Model: IF2		Date: 15-Jul-97	No: 001
Subject: NCU Parameters		Prepared by: Y.Tamaoka	
From: QAC 2nd Field Information Dept.			
Classification:	<input type="checkbox"/> Troubleshooting	<input type="checkbox"/> Part information	<input type="checkbox"/> Action required
	<input type="checkbox"/> Mechanical	<input type="checkbox"/> Electrical	<input checked="" type="checkbox"/> Service manual revision
	<input type="checkbox"/> Paper path	<input type="checkbox"/> Transmit/receive	<input type="checkbox"/> Retrofit information
	<input type="checkbox"/> Other ()

Model: IF2		Date: 15-Dec-97	No: 006A
Subject: TAD mode		Prepared by: K.Moriizumi	
From: QAC Field Information Dept.			
Classification:	<input checked="" type="checkbox"/> Troubleshooting	<input type="checkbox"/> Part information	<input type="checkbox"/> Action required
	<input type="checkbox"/> Mechanical	<input type="checkbox"/> Electrical	<input type="checkbox"/> Service manual revision
	<input type="checkbox"/> Paper path	<input type="checkbox"/> Transmit/receive	<input type="checkbox"/> Retrofit information
	<input type="checkbox"/> Other ()

Model: IF2		Date: 15-May-98	No: 007
Subject: Paper Jam (No Feed)		Prepared by: Y.Tamaok

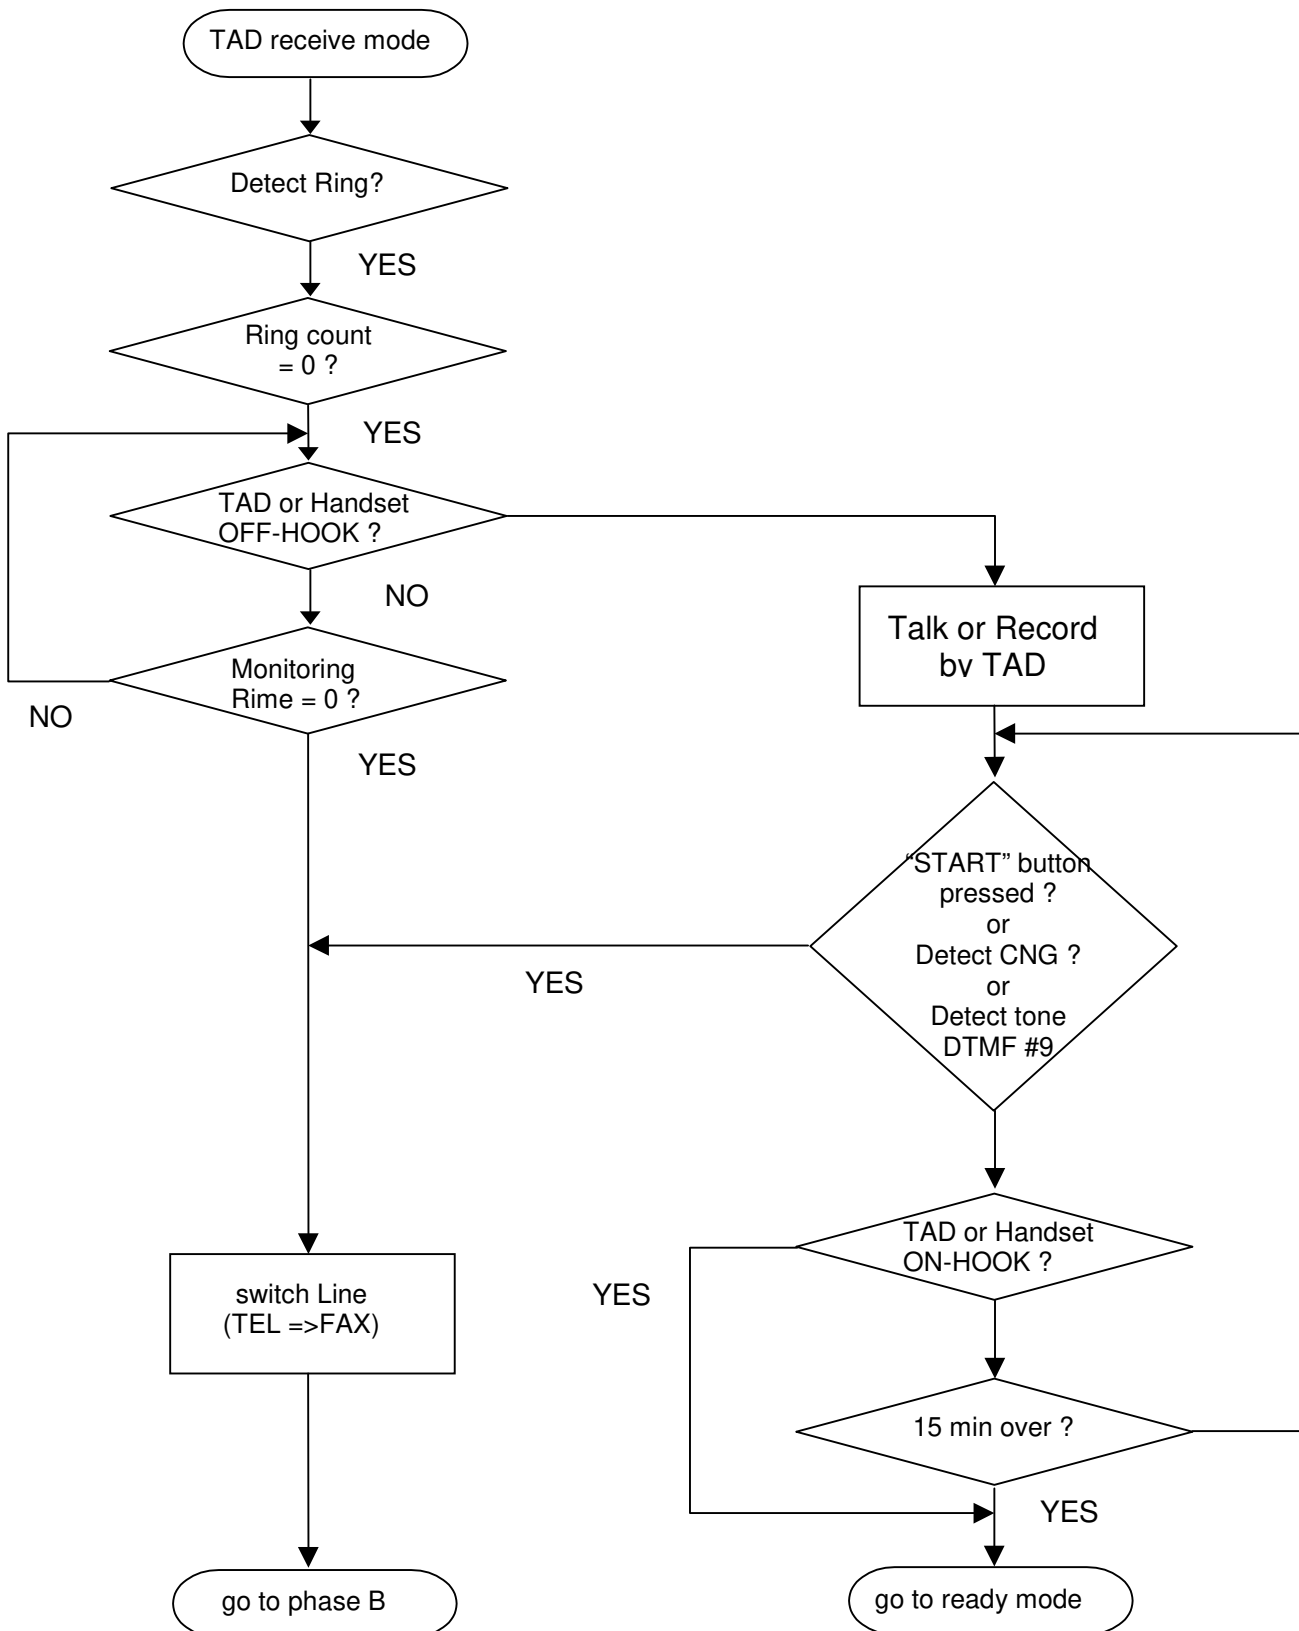
In the Operation Manual of the FAX680MP, the TAD ring count of the FAX680MP must be at least one more than the answering ring count of the telephone answering device. For example, when the telephone answering device is set to ring once, the TAD ring count of the FAX680MP must be set to two rings or more.

---> (TAD ring count) < (FAX680MP TAD ring count)

However, the FAX680MP does not monitor the telephone line with the above setting. The TAD detects the ring and closes the telephone line earlier than the FAX680MP. Then FAX680MP cannot detect the ring.

The TAD ring count of the FAX680MP must be ***always be set to one ring.***

---> FAX 680MP TAD ring count=1

Also, the monitoring time must be longer than the answering ring time of the telephone answering device. However, if the monitoring time is longer than the T1 timer of the transmission fax terminal, the FAX680MP cannot receive the fax message.

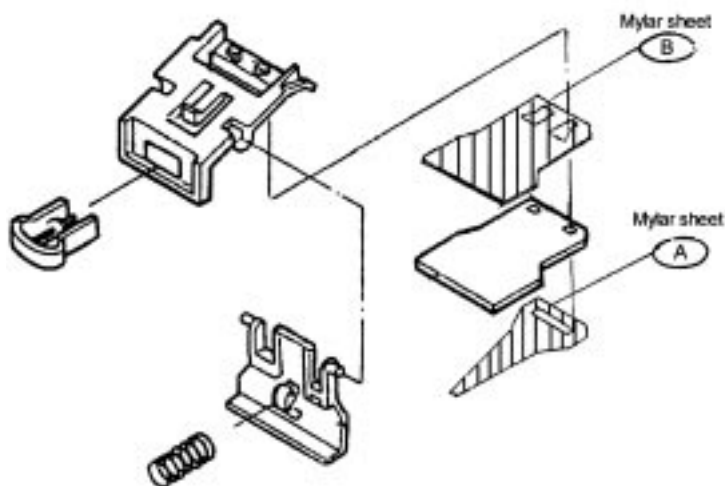
Originals not fed to the scan line leading to an error indication.

The force to feed documents decreases after a few months operation because of dust and oil from originals, depending on the types of originals used by the customer.

Add two Mylar sheets (H9059800) to the ADF holder ass'y as shown in the drawing below.
